Willow Island Park Enhancements Community Oversight Committee Progress Meeting

### **Willow Island Park Enhancements Community Oversight Committee Progress Meeting**

Contract # C1001636

L-002

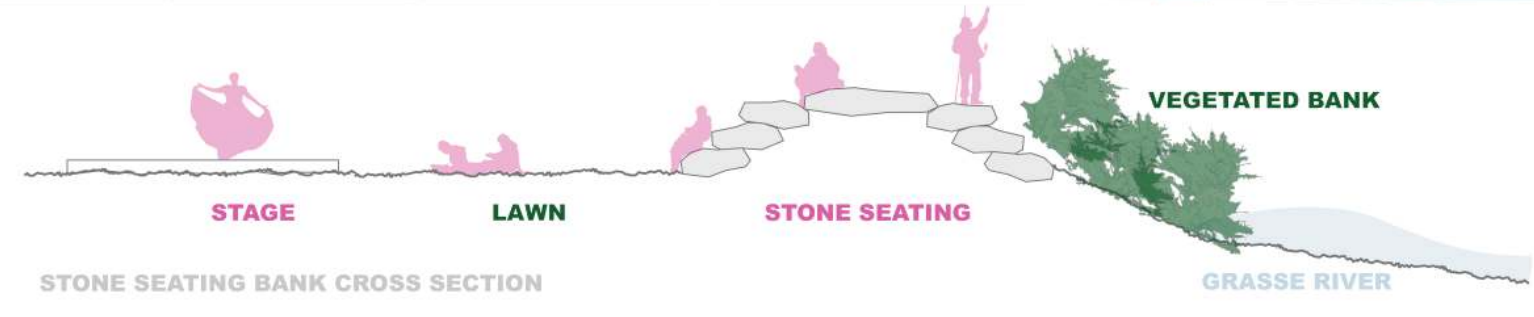
- Path
  - The path should be a minimum of 8' wide.
  - Accessible for vehicles for maintenance and performers to unload.
  - It was noted that there is a gravel road where the trail is (underneath the grass) in Diagram 2.
